Dėl atominės elektrinės Baltarusijoje projekto

DĖL PLANUOJAMOS BALTARUSIJOS ATOMINĖS ELEKTRINĖS POVEIKIO APLINKAI VERTINIMO ATASKAITOS

VIEŠO VISUOMENĖS SUPAŽINDINIMO SU PLANUOJAMOS ATOMINĖS
ELEKTRINĖS BALTARUSIJOJE POVEIKIO APLINKAI VERTINIMO ATASKAITA

We would like to thank you for the bilateral meeting regarding the environmental impact assessment (EIA) of the construction of the nuclear power plant in the Republic of Belarus, that was held on June 18, 2010. According to the understanding reached during the meeting, we would like to present our view on the outcomes and the overall EIA process:

Fig. P.6 - Drawing of Scenario 1. Fields of Density of Pollution of the Territory ¹³¹I and Cs-137 (trace C3)

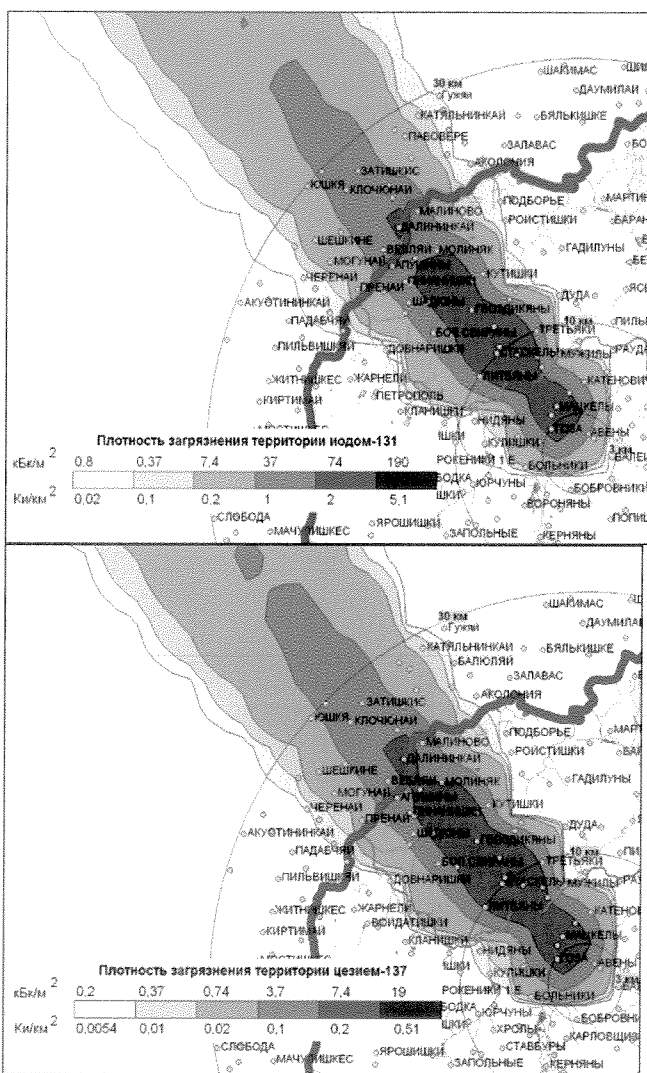
24.	More background information on the beyond design-basis accident scenarios and the graphic information on the fields of density of pollution of ¹³¹ I and ¹³⁷ Cs radionuclides is given in the answer. But the graphic information on contamination levels of radionuclides is given only for the 1 st scenario. The Report should be supplemented with the graphic information on contamination levels of radionuclides for the 2 nd scenario also.	In EIA 2 most conservative scenarios have been presented: - the scenario of pollution of small area, Table 139, Figure 96, The scenario of pollution of a great area, Table 140, Figure 97,

Fig. P.7 - Drawing – Change of the Total Effective Dose of Irradiation with a Distance from the Source of Emission

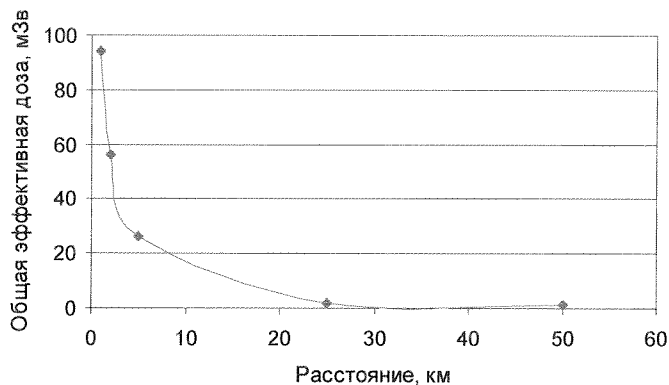
Question 28. Maximum doses at the accidents which are not connected with design study have been calculated, but anywhere in the Report on EIA has not been specified that the risks are admissible. In case if the graphic information on distribution of the doses among the population is presented, it is necessary to present the analysis of the given results and conclusions. Also it is not clear on which directions of movement of air masses the calculations are based. The estimation of Lithuania should be conservative, and the worst scenario should be considered.

RESPONSE: the analysis of the doses of irradiation has shown that against the background of decrease of the general effective dose with a distance contribution of an inhalation component of the dose decreases with moving away from the emission source while contributions of the doses from a cloud and discharges increases.

Fig. P.13

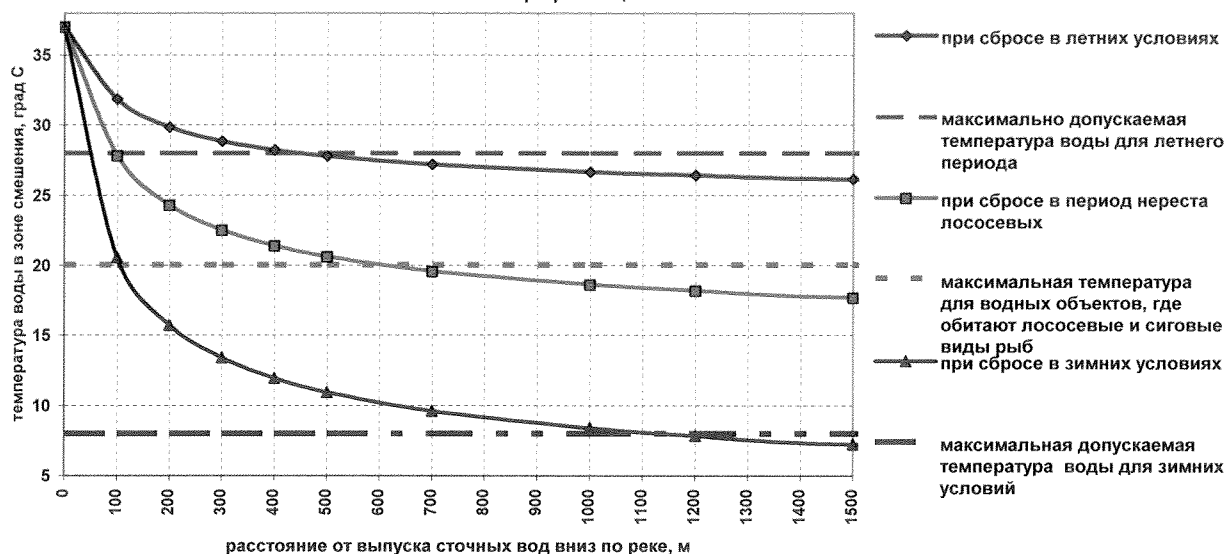
37. Please clarify if there will be any thermal load into Neris (Vilija) river. If yes, the dispersion of thermal load should be modeled and the results should be given in the EIA report. This issue is very important as thermal pollution can have significant impacts on flora, fauna especially cold-water species, benthos and other water organisms of Neris (Vilija) river. Moreover, during the preparation of monitoring program, this important aspect should also be taken into account. Please describe what studies will be included in the monitoring program.
